NAVY EXPERIMENTAL DIVING UNIT

REPORT NO. 7-88

LIGHT WEIGHT DIVING SYSTEM (LWDS) PROTOTYPE
TECHNICAL EVALUATION - HUMAN FACTORS,
TRANSPORTABILITY AND SUITABILITY

Figure 2. Diesel-Compressor Unit

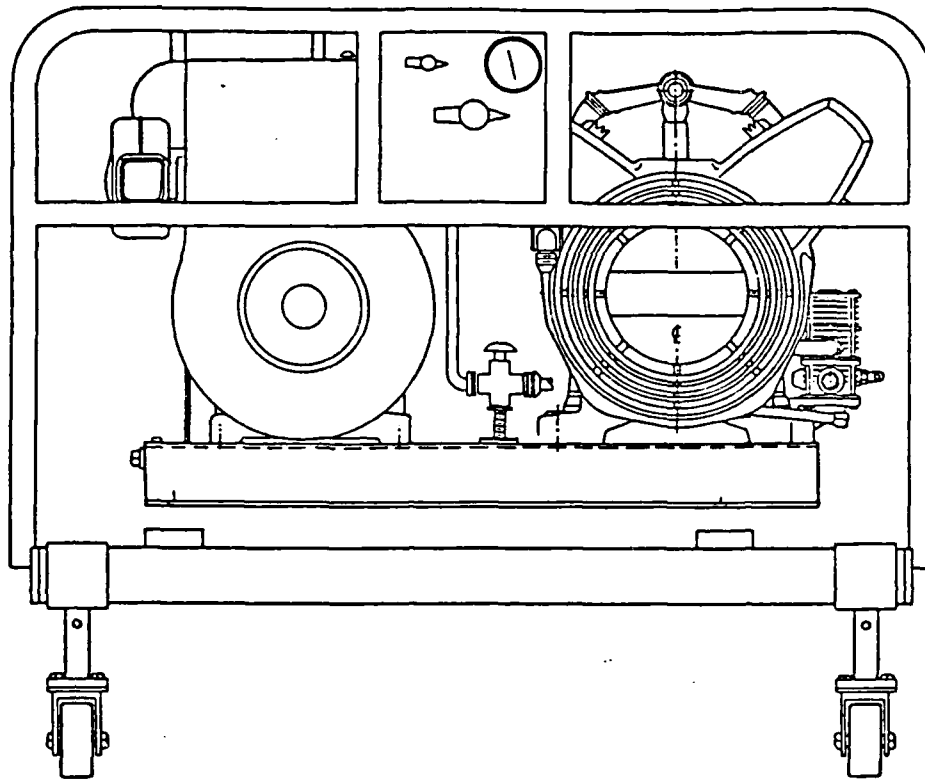
1. It was a simple system to operate.
2. The diesel-compressor unit is an extremely heavy, awkward lift for four men, that significantly exceeds MIL STD 1472C recommended limits.

4. The team was uncomfortable with the fuel tank mounted over the compressor inlet and the compressor oil filter co-centric with the inlet filter housing. Failure of the filter housing seal could result in air contamination.

Figure 5. Divers' Control Console and Volume Tank Unit

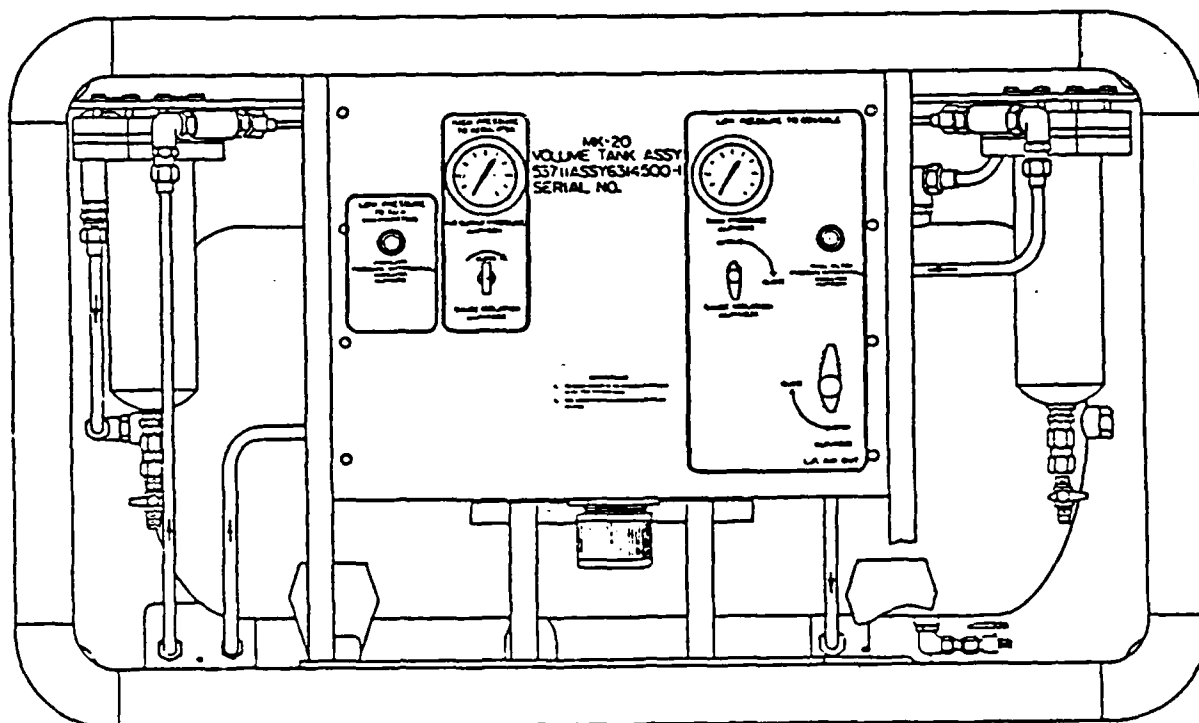
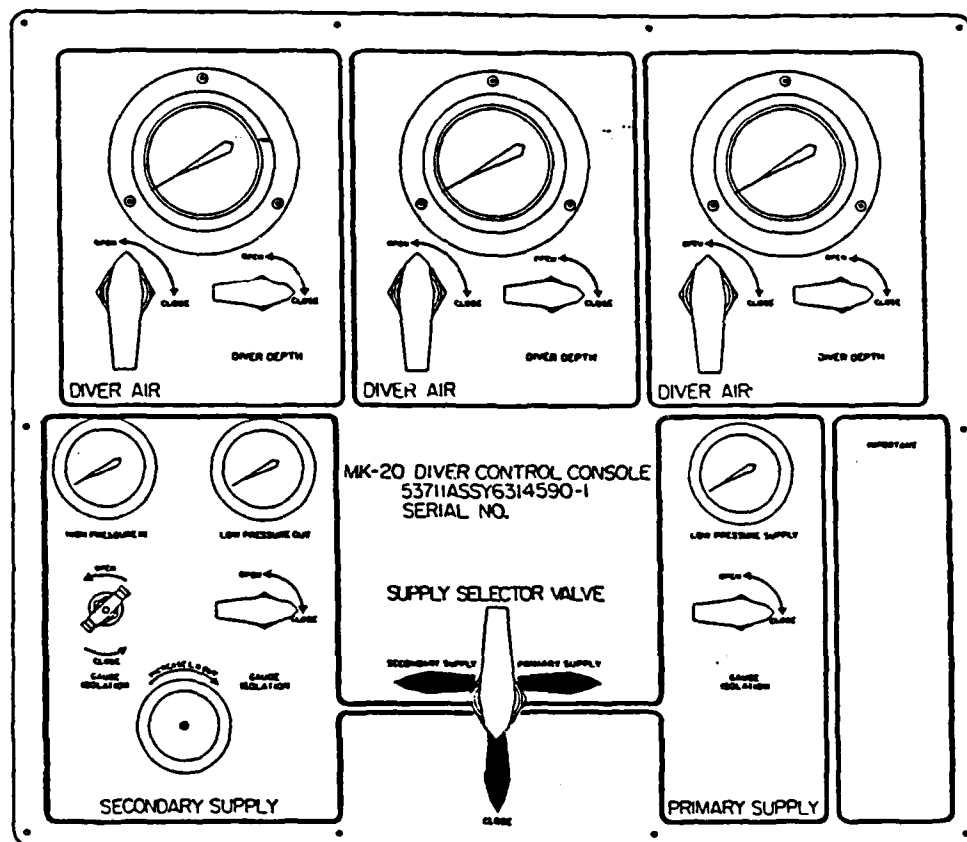
<u>REFERENCE</u>	<u>DEFICIENCY DESCRIPTION</u>	<u>SUGGESTED CORRECTION</u>
5.4.1.8.1	Supply Selector Valve on Diver Control Console contains no positive protection to prevent valve handle from being moved to the closed position which turns off the divers' air supply. Currently the level of friction on this valve, combined with the control design, makes this fairly hard to do by accidentally bumping against it.	Provide positive locking detente at each selector position, which must be overridden before switch can be moved. In addition to completely removing risk of turning off divers' air by accident, this would also remove operator uncertainty about whether the selector is properly positioned to provide free air flow to diver.

5.5.3.1	(1) All controls and functions labelled on the Diver Control Console as "Secondary Supply" are commonly referred to by the divers as "Emergency Supply" which more appropriately describes their function.	All labels and instructions referring to "Secondary Supply" should be changed to read "Emergency Supply". This change should also be reflected in all manuals.

<u>REFERENCE</u>	<u>DEFICIENCY DESCRIPTION</u>	<u>SUGGESTED CORRECTION</u>
5.7.2.2	Guages on Volume Tank Unit are located less than 41 inches above the standing surface. They are extremely difficult to read.	Integrate the HP primary guages and controls into the Diver Control Con- sole as proposed in Figure 6 of the report. This would leave only the filter pressure in- dicators and the valve control and pressure guage for the Volume Tank on the lower panel.

Figure 6. Proposed Changes to the LWDS

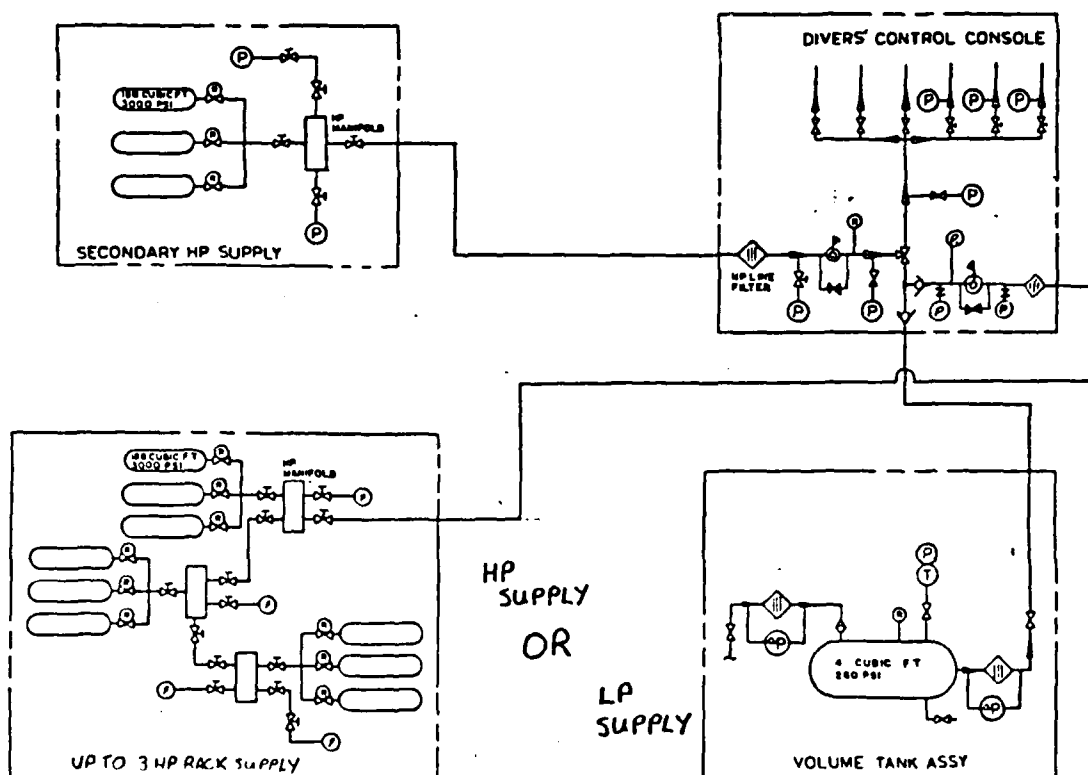
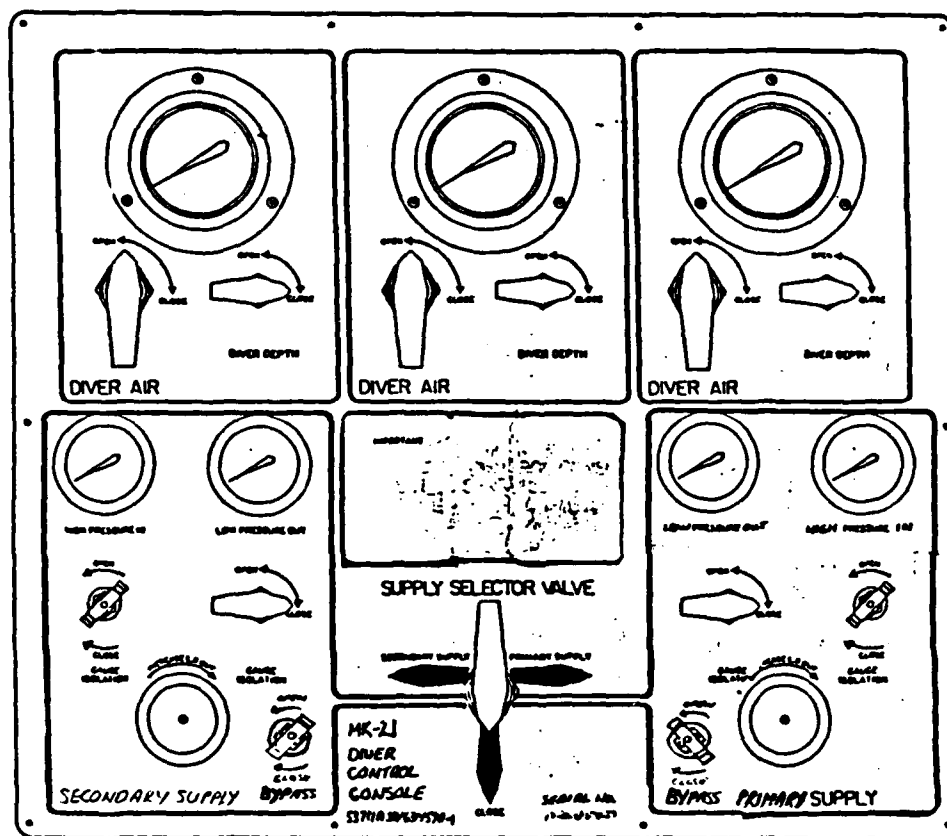
The above considerations slightly modify the prototype LWDS. If significant redesign were done, the console could be miniaturized and the HP air racks could be expanded to 4 flasks per rack with one isolated for secondary supply. Similar systems are currently in use in Canada and the United Kingdom and weigh about 400 pounds (without HP compressor).
